Access Compliance Report Public Rights-of-Way (Curb Ramps)

Main Street: KENSINGTON_RD Cross Street: BOSTONIAN_DR Location: NE

ADA ID: RPRK211220130033 Ramp Type: Type 1 - Perpendicular Diagonal Initial Pass/Fail: Pass Overall Compliance: No Severity Score: 5

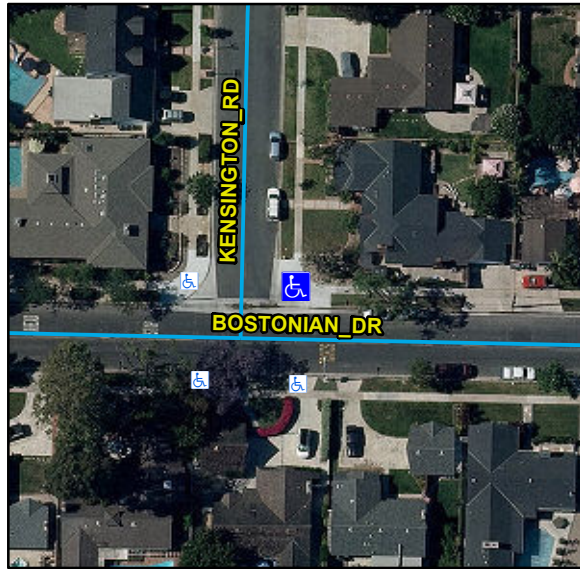
N/A	Ramp Inside Crosswalk 1	N/A	Yes	Ramp Inside Crosswalk 2	N/A
	Crossing 1 Slope (%)	3.6		Crossing 2 Slope (%)	7.2
	Crossing 1 Cross Slope (%)	0.7		Crossing 2 Cross Slope (%)	1.7
Yes	Gutter Ponding	No	Yes	Curb Slope	3.1
Yes	Gutter Lip Height (in)	0		Road Run Slope (%)	2.4
No	Gutter Run Slope (%)	5.3		Road Cross Slope (%)	4.4
Yes	Gutter Cross Slope (%)	1.2			
Yes	Overall Surface Condition: Acceptable		Yes	Perp Joint Present	Yes
	Cross Gutter Present?	Yes		Spandrel Present?	Yes
	Replace Cross Gutter?	No		Replace Spandrel?	No

Remove & Replace Gutter.
